**Subject: Plan of Action for Cell Certification  
Enterprise Recycling & Disposal Facility  
Angelo's Aggregate Materials, Ltd.  
FDEP Permit Nos. 177982-001-SC, 177982-002-SO  
Pasco County, Florida**

DATE: AUGUST 19, 2003  
TIME: 0900  
SUBJECT: ENTERPRISE WASTE TREATMENT LANDFILL

**ANGELO'S AGGREGATE MATERIALS, LTD.  
ENTERPRISE RECYCLING & DISPOSAL FACILITY  
PROPOSED MEETING AGENDA  
August 19, 2003**

CELL No. 1 - CROSS-SECTION B-B' - CERTIFICATION  
ENTERPRISE RECYCLING AND DISPOSAL FACILITY  
DADE CITY, FLORIDA

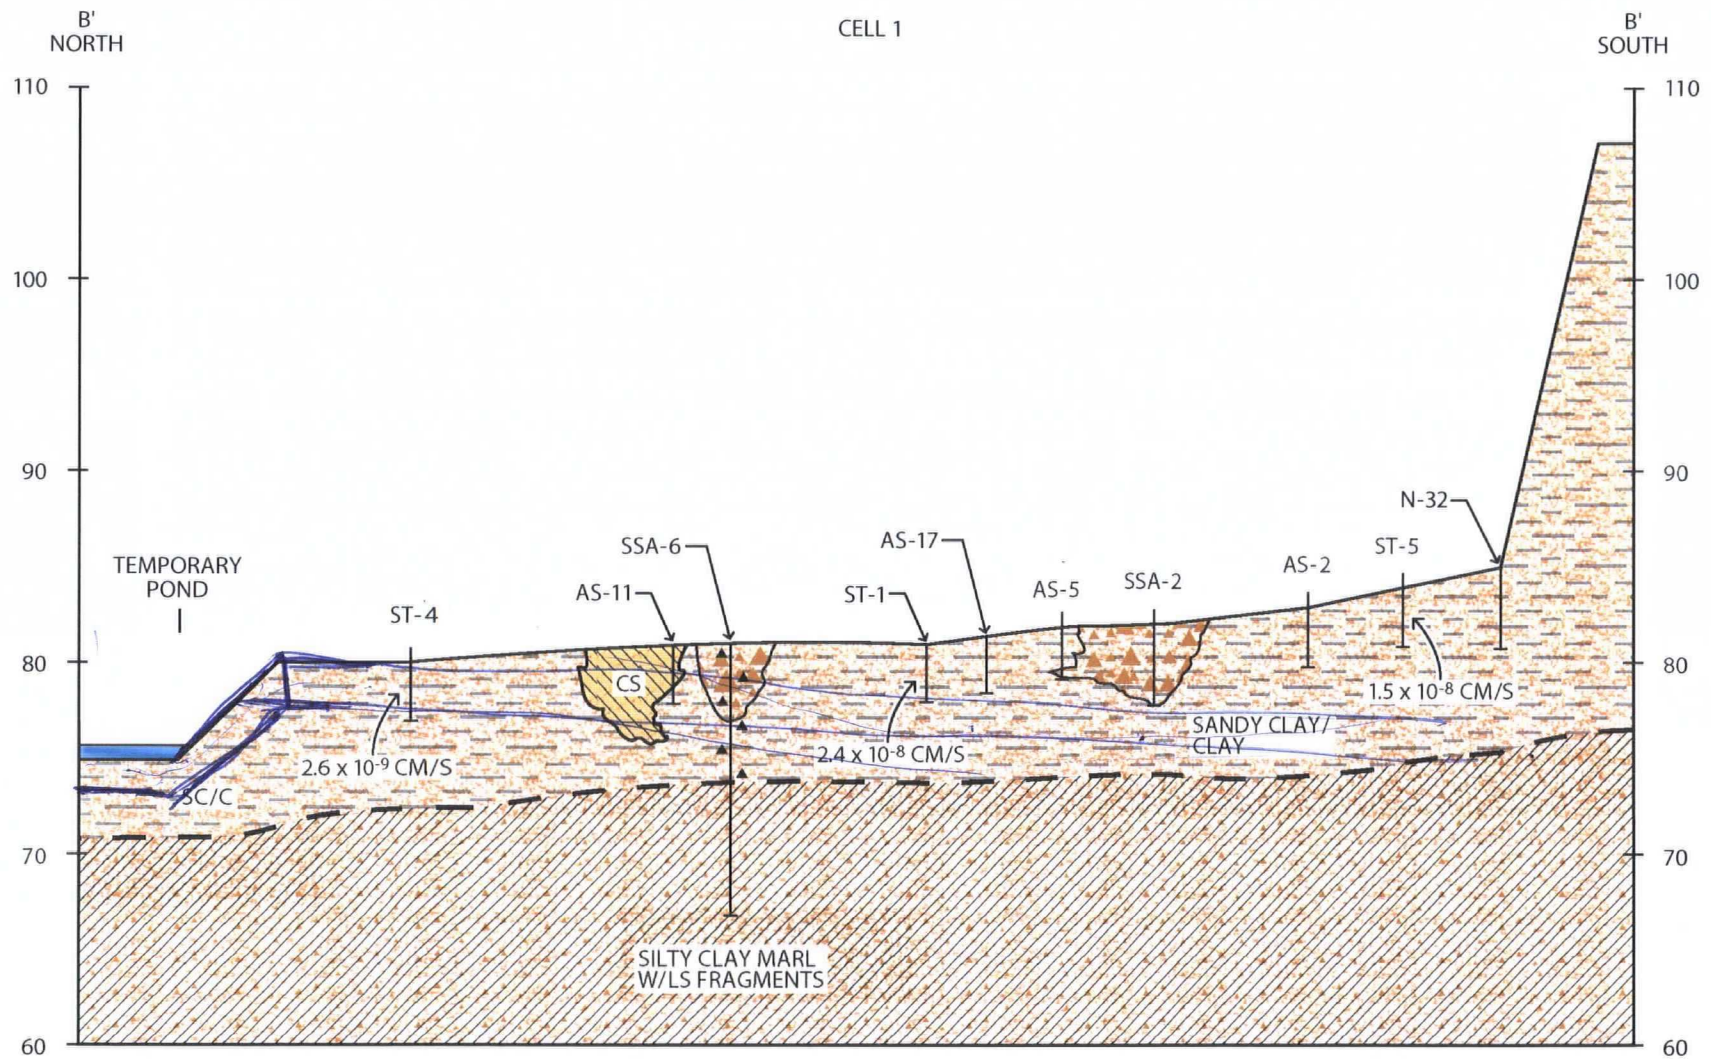
- 11 additional borings, deep enough to show  $3 \text{ ft} \times 10^{-6}$
- worst case locations for peans
- sieves on All borings
- # of peans depends on variability

will survey locations of patches in cell 1  
Hartman will be observing

Cell 1 sandy area will do ~~deep~~ borings to try & fix in small area will excavate &

- do All borings upto where "you're secure"  
& back off from "bad" areas for this certification
- do testing to decide what repairs need to be done

CELL No. 1 - CROSS-SECTION B-B' - CERTIFICATION  
ENTERPRISE RECYCLING AND DISPOSAL FACILITY  
DADE CITY, FLORIDA

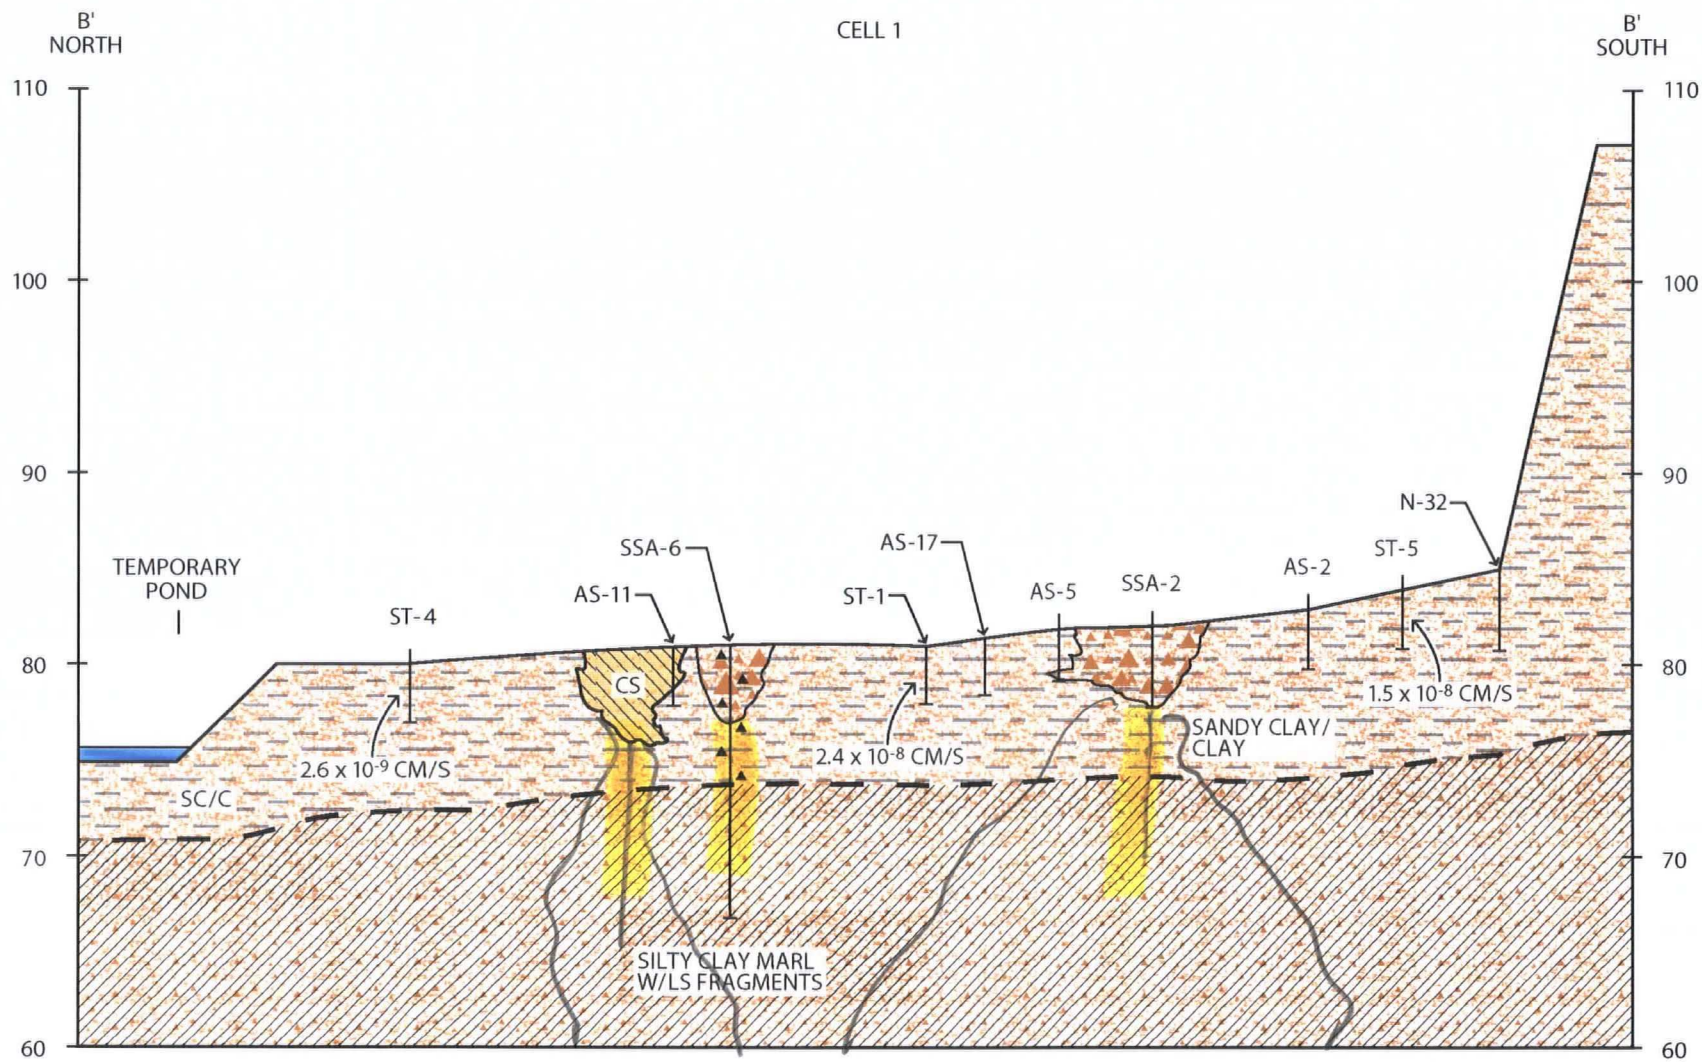
SP - NOT ADJUDICATING, INTENT IS 3' THICK  
AND CONTINUITY IS IMPORTANT

NEW CROSS SECTION INADJUDICATE

SP SAID CHOOSE SHALLOW OR DEEP

AND MUST KNOW PERMEABILITIES

AGREED WE WOULD A

TOP OF CLAY CONTOUR MAP W/CLAY THICKNESS

AND TABLE WITH PERM. VALUES

FOR EACH LOCATION

SP/ ASKED FOR NEW PLAN OF ACTION
